CITY OF BLOOMINGTON

**CITY OF BLOOMINGTON
PLAN COMMISSION AGENDA
July 7, 2014 @ 5:30 p.m.**

**BLOOMINGTON PLAN COMMISSION
STAFF REPORT
Location: 526 N. Morton Street**

**BLOOMINGTON PLAN COMMISSION
STAFF REPORT
Location: 700–730 N. Walnut Street**

SP-16-14
Site plan and first floor

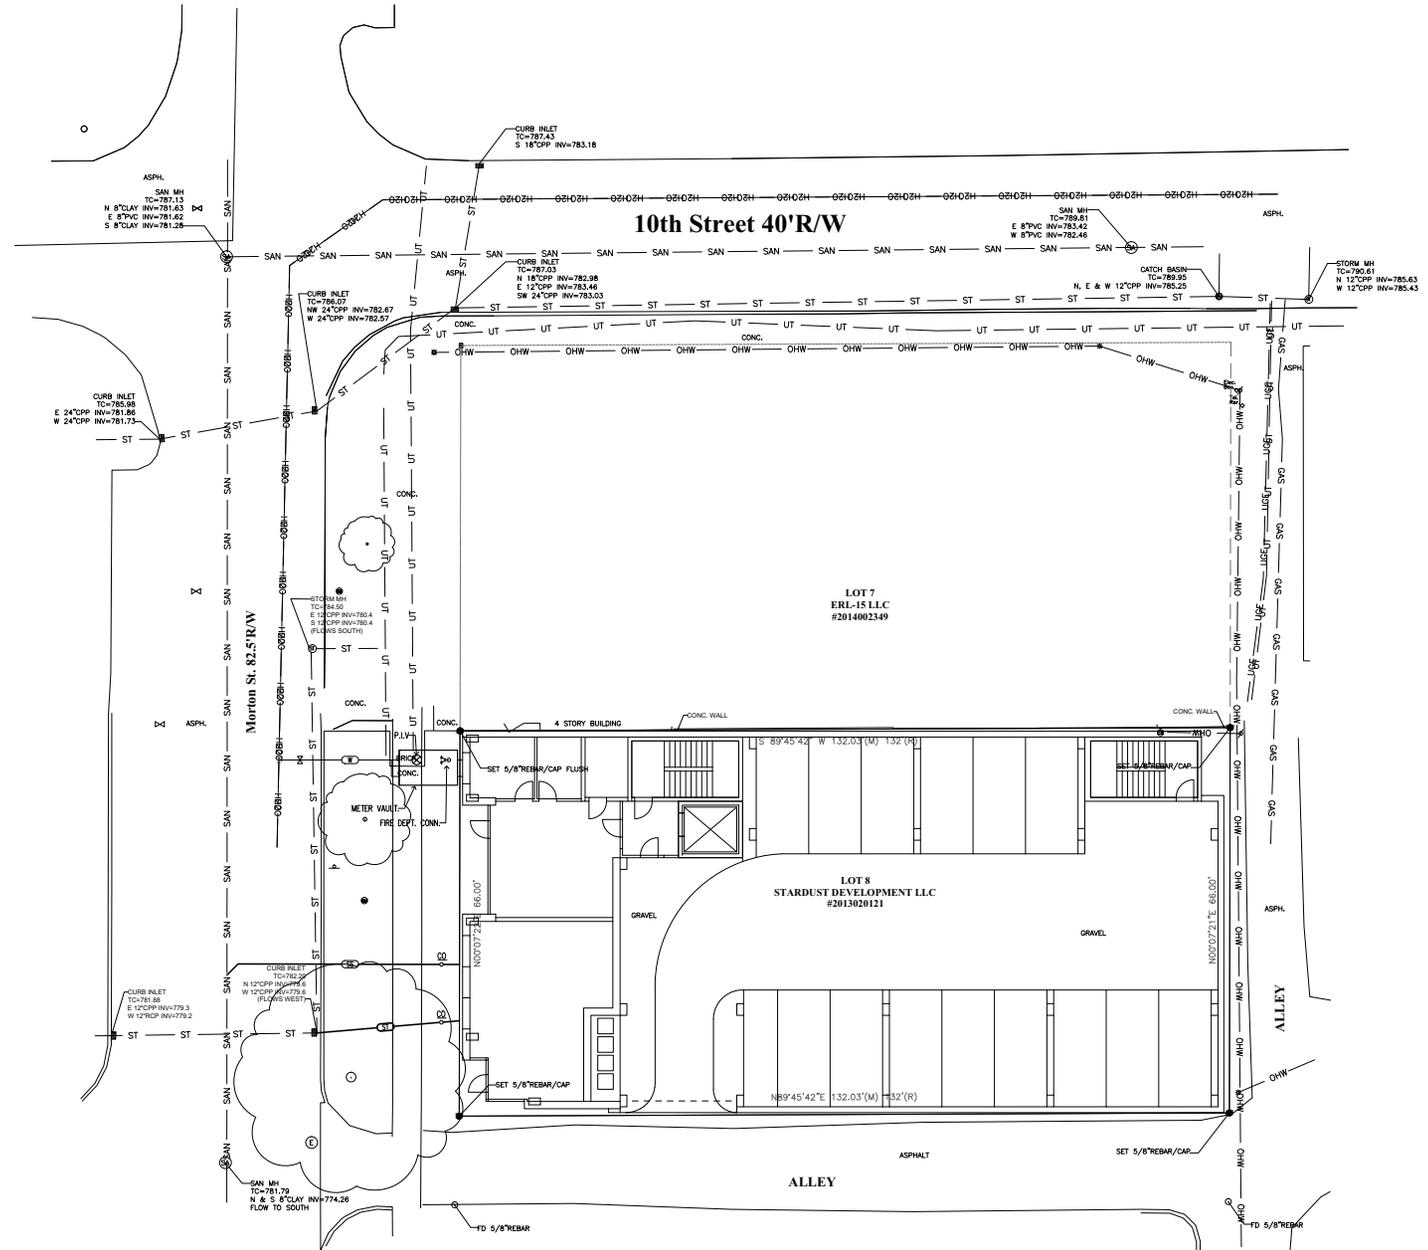
Parking Waiver-20.03.120(c)(2): Staff finds that the proposed 18 parking spaces will not adequately meet the needs of the building. The Downtown Vision and Infill Strategy Plan (hereafter referred to as “Downtown Plan”) (Pg.4-13) recommends 0.8 spaces per bedroom. The petition provides only 0.57 spaces per bedroom. If the 5th floor and its 11 bedrooms were removed, the project would require 16 spaces, which would be satisfied by the proposed 18 spaces. Staff recommends denial of this waiver.

Bicycle Parking: A 44 bedroom multi-family development requires 8 bicycle parking spaces. In addition, the commercial space requires 4 bicycle parking spaces for a total of 12 spaces. The site plan currently shows 8 class-2 spaces along Morton St. and 8 Class-1 spaces inside of the garage. This exceeds minimum requirements.

BUILDING ELEVATIONS (1/16" = 1'-0")

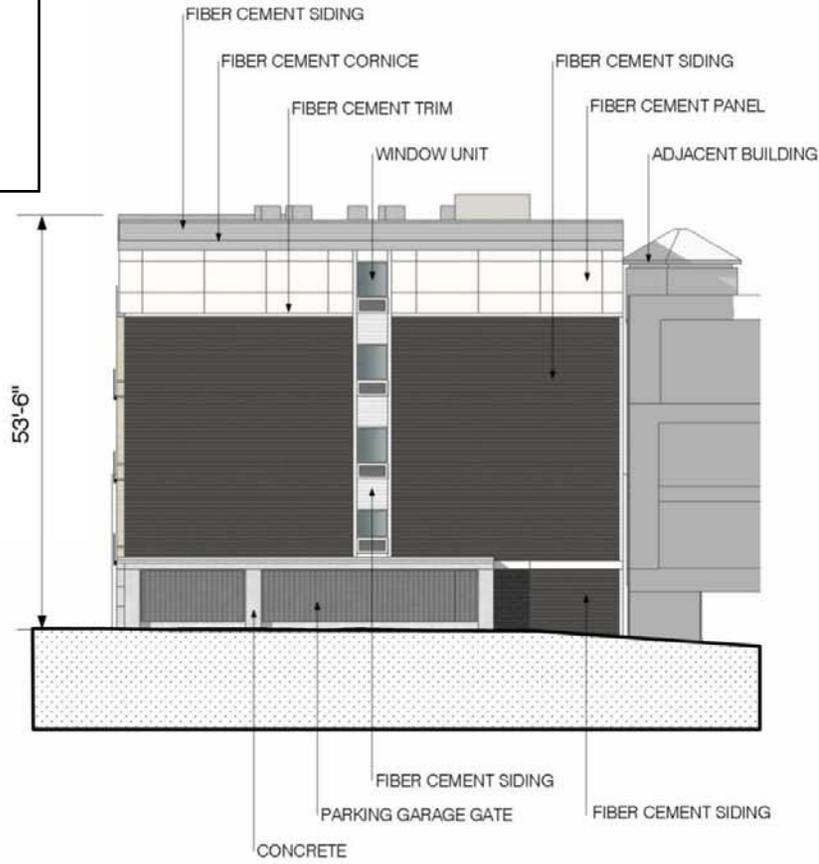
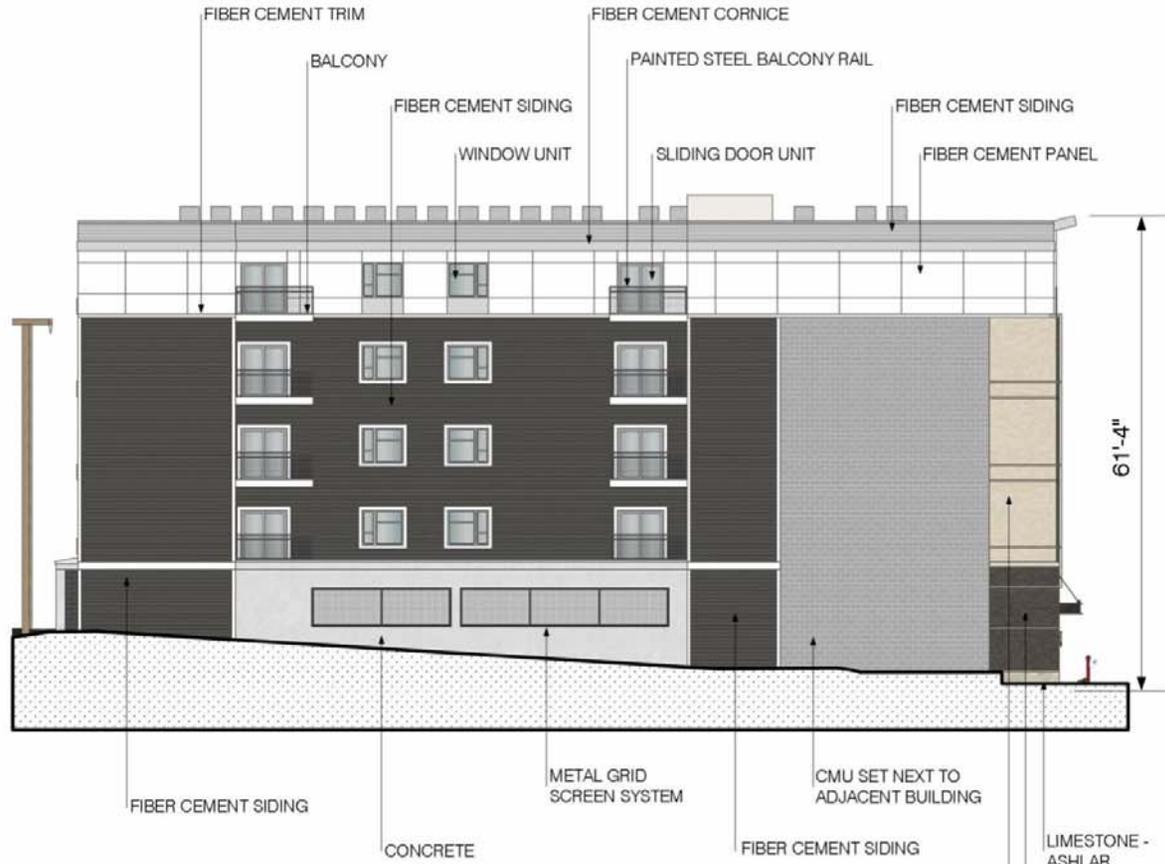
Height Waiver-20.03.120(b)(2): A waiver from the architectural standard of the UDO is required to allow a height of more than 50 feet. The Downtown Plan, in the intent for the Downtown Core area (Pg. 2-5), states that "parcels in the Downtown Core Character Area can accommodate taller structures and should be encouraged when they are designed to reflect the traditional scale of buildings at the street level and are articulated into modules that are compatible with the traditional design context." Guideline 3.9 recommends that new buildings "maintain the perceived building scale of two to four stories in height." It goes on to state that "if a building must be taller, consider stepping upper stories back from the main façade." The proposed building is five stories in height which is taller than the recommended 4-story height of the Downtown Core. In addition, the building height is taller than the established height pattern between this property and 11th Street. While the Springhill Suites hotel was approved at 71 feet, staff at the time found that additional height was necessary for the unique nature of the use as well as the context of the building adjacent to the much taller Smallwood Plaza. Staff recommends denial of this waiver based on the height recommendations in the Downtown Plan as well as height context of the site. In addition to the four story buildings north of the site, the property is adjacent to historic building locations.

Material Waiver-20.03.130(b)(4)(A)(v): A waiver from the standards of the UDO is required to allow concrete block and cementitious siding and panels as a primary exterior finish materials, covering more than 20% of the south façade, and to allow poured concrete as an exterior finish material. If the Plan Commission disagrees with staff on the parking and height waivers, the Commission will need to render findings for this waiver.

Site Plan / First Floor Plan

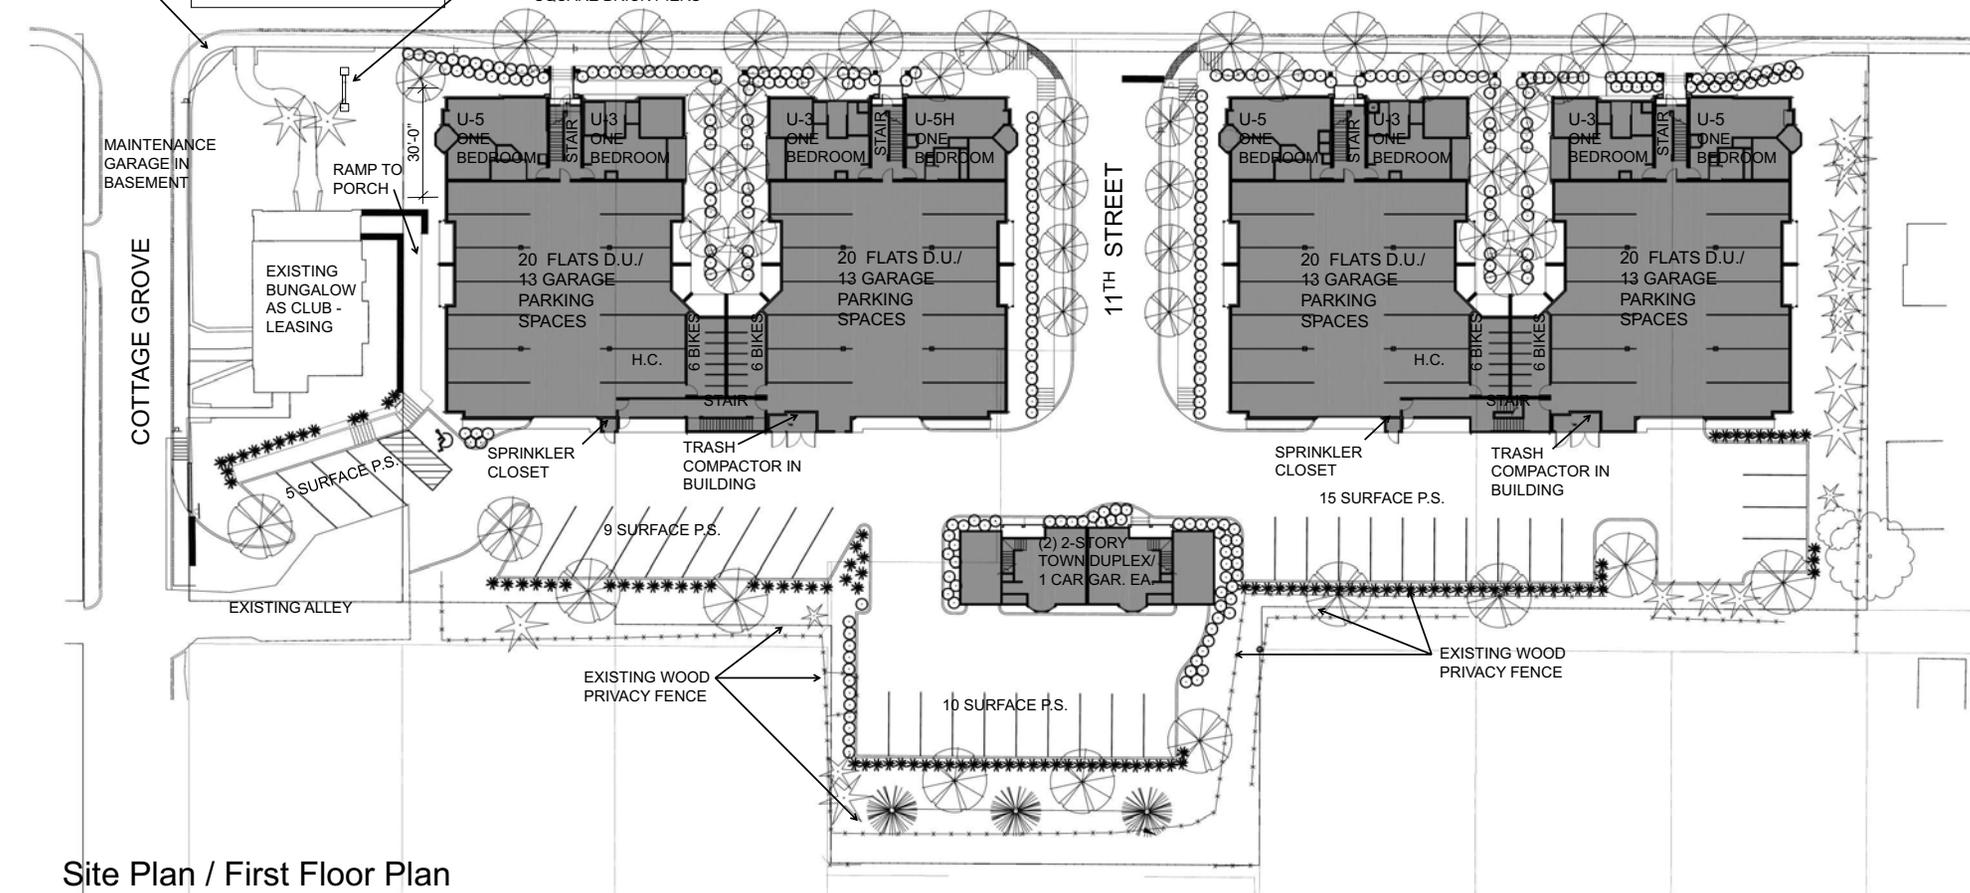
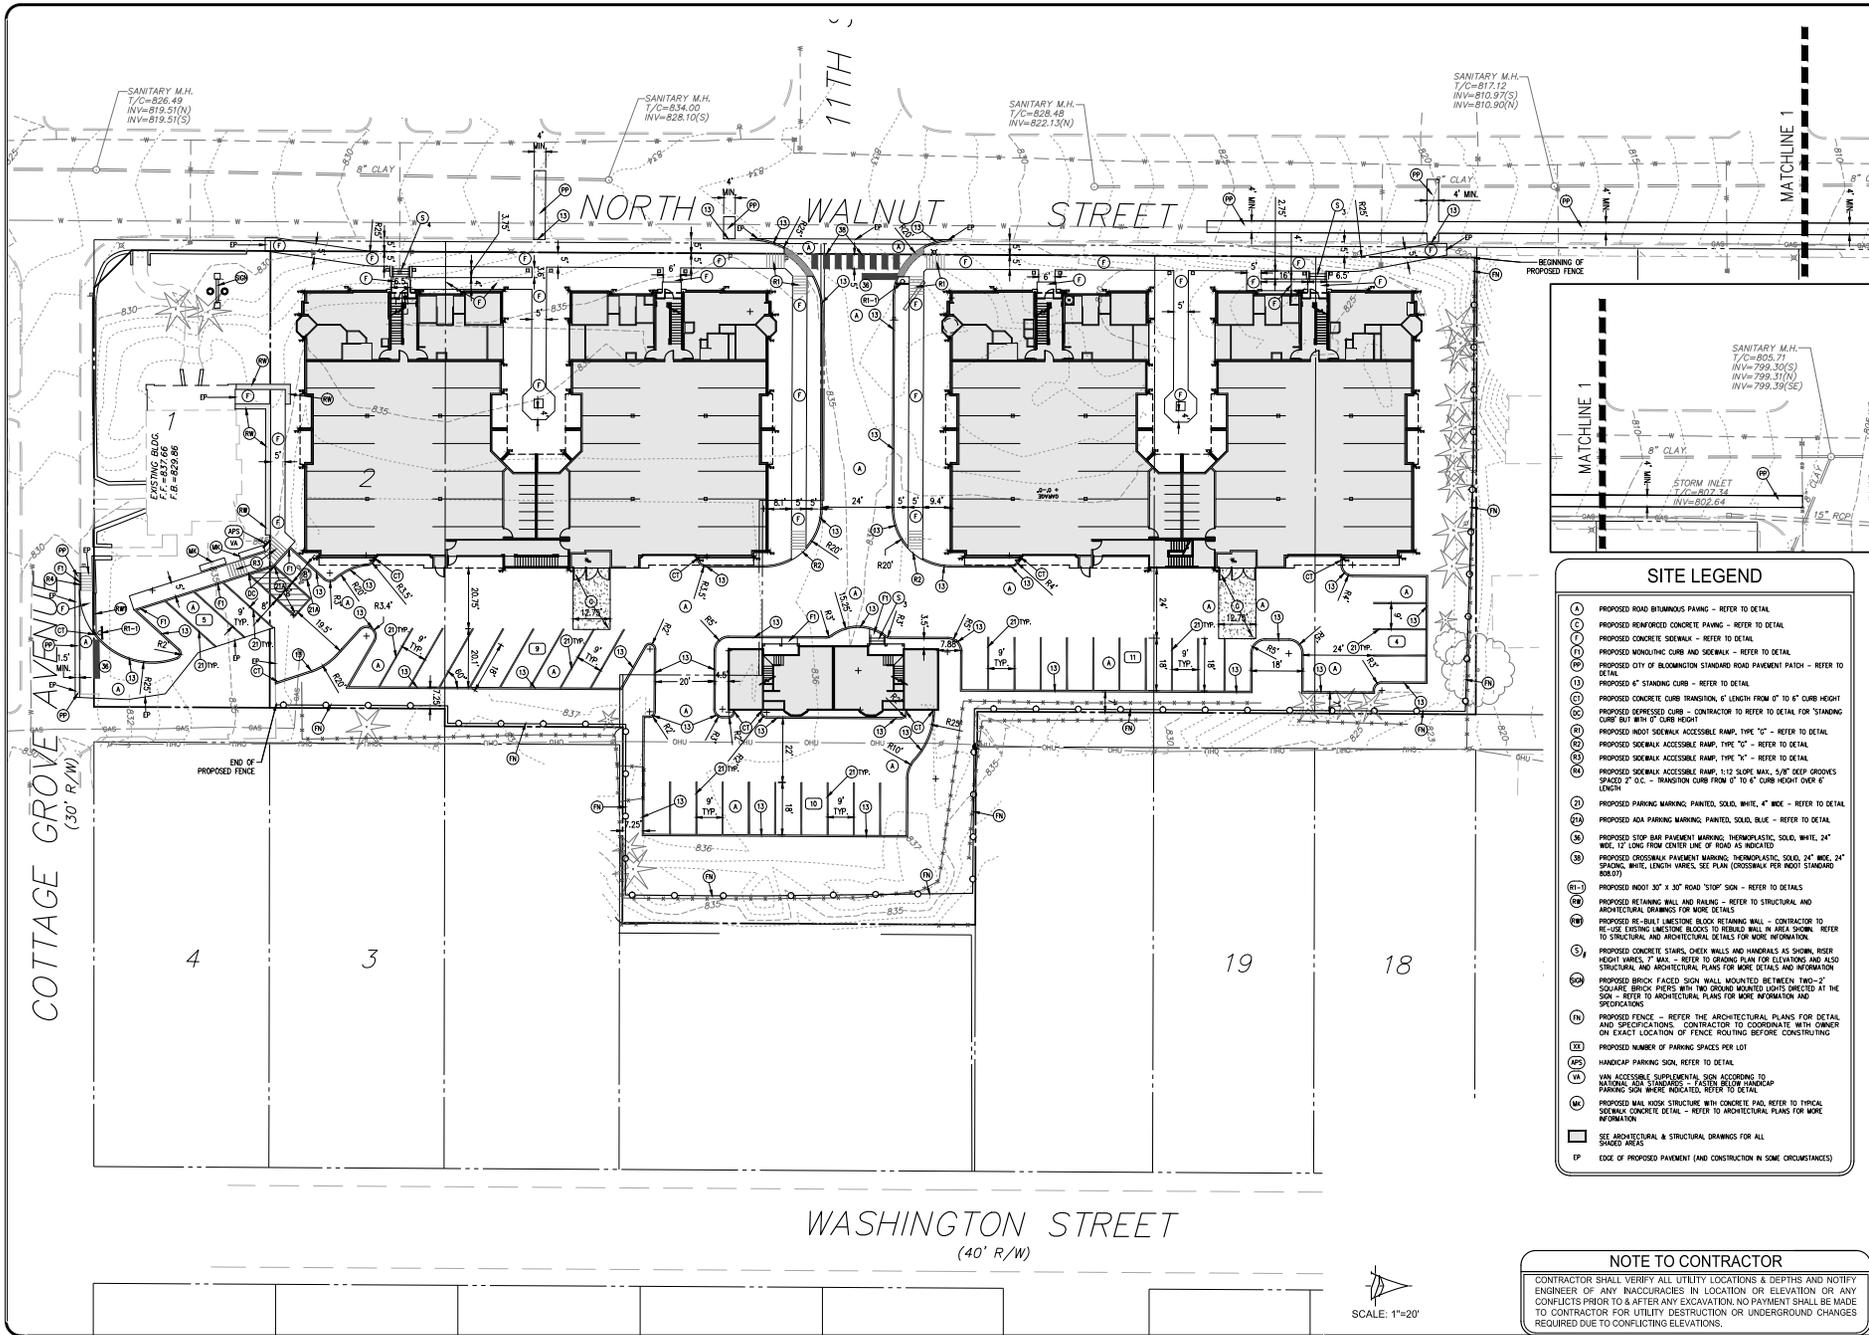
Parking: The DEO would permit a parking range between 68 and 84 parking spaces for this development. Due to the high number of one-bedroom units that may include couples, the petitioner is requesting to increase the parking they would provide to approximately 91 spaces. This results in a ratio of 1.08 spaces per bedroom, slightly over the maximum of 1 space per bedroom. Due to the parking pressures associated with the surrounding neighborhood parking zone (Zone 5), staff is supportive of a variance to allow this increase. In addition, staff would recommend that such an approval include a restriction that potential tenants would not be able to receive Zone 5 permits or visitor tags.

Staff presented the proposed site plan and reduced front setback to the Bloomington Historic Preservation Commission (HPC) to receive feedback on the appropriateness of the proposed building location. Largely due to the location of the historic structure at an intersection, the HPC expressed support for the new building location and did not believe the placement of the structure would detract from the visibility of the historic structure. ***A waiver from this standard has been requested.***
